MEMORANDUM

DATE: September 12, 2003
TO: Montgomery County Planning Board
VIA: Joe R. Davis, Chief *J.R.D.*
Development Review Division
FROM: Michael Ma, Supervisor *Ma*
Development Review Division
(301) 495-4523

REVIEW TYPE: Site Plan Review
CASE #: 8-03039
PROJECT NAME: Hodges Lansdale Property
APPLYING FOR: Approval of 30 one-family dwelling units including one existing home

10. Signature Set

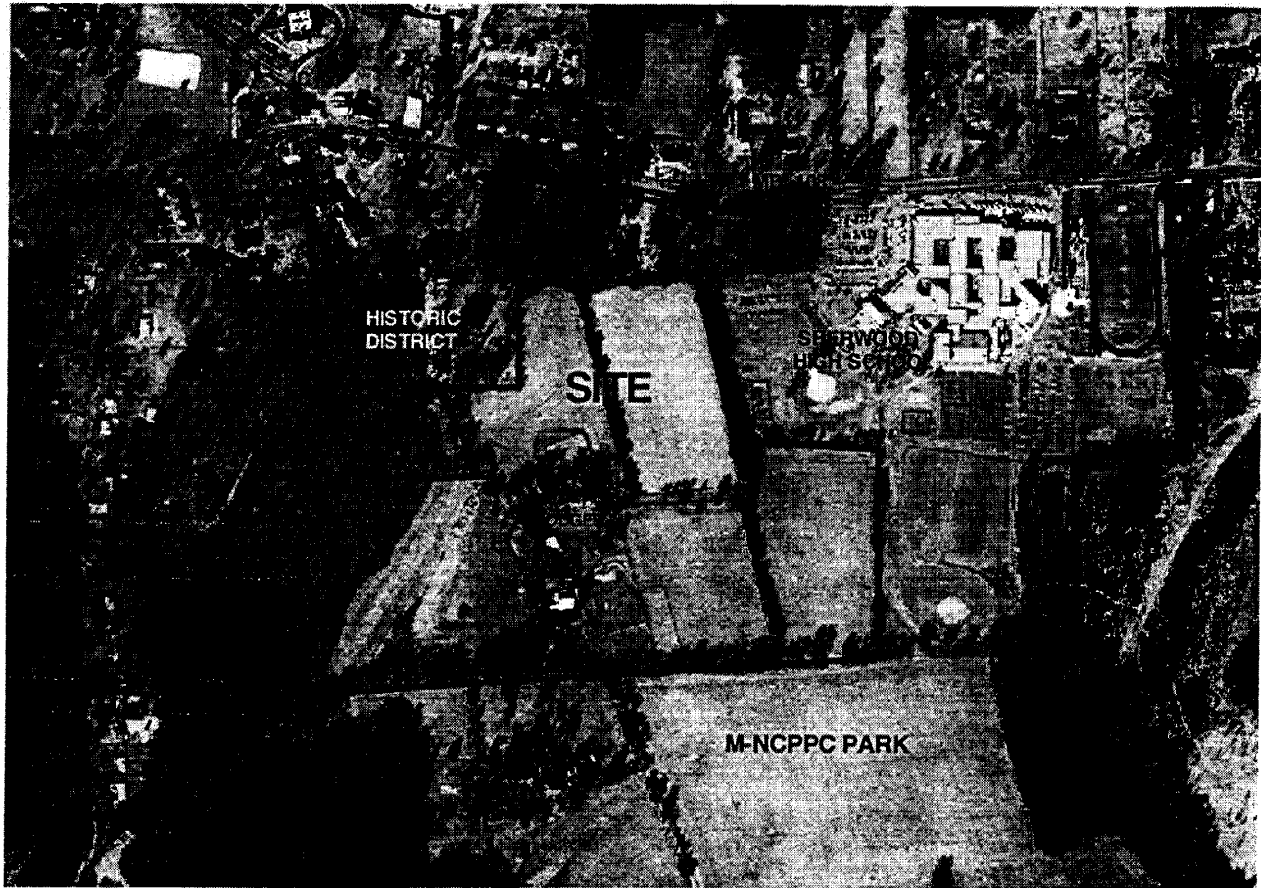
Prior to signature set approval of site and landscape/lighting plans the following revisions shall be included and/or information provided, subject to staff review and approval:

- a. Locations and details of benches in the proposed common open areas.
- b. Details of the proposed 36-inch-high picket fence and natural surface trail.
- c. A 36-inch-high split-rail fence along the rear property lines of Lots 5 and 6.
- d. Methods and locations of tree protection.
- e. Forest Conservation areas.
- f. Note stating the M-NCPPC staff must inspect tree-save areas and protection devices prior to clearing and grading.
- g. The development program inspection schedule and Site Plan Opinion.
- h. Conservation easement boundary.
- i. Alternative storm drain outfall location.
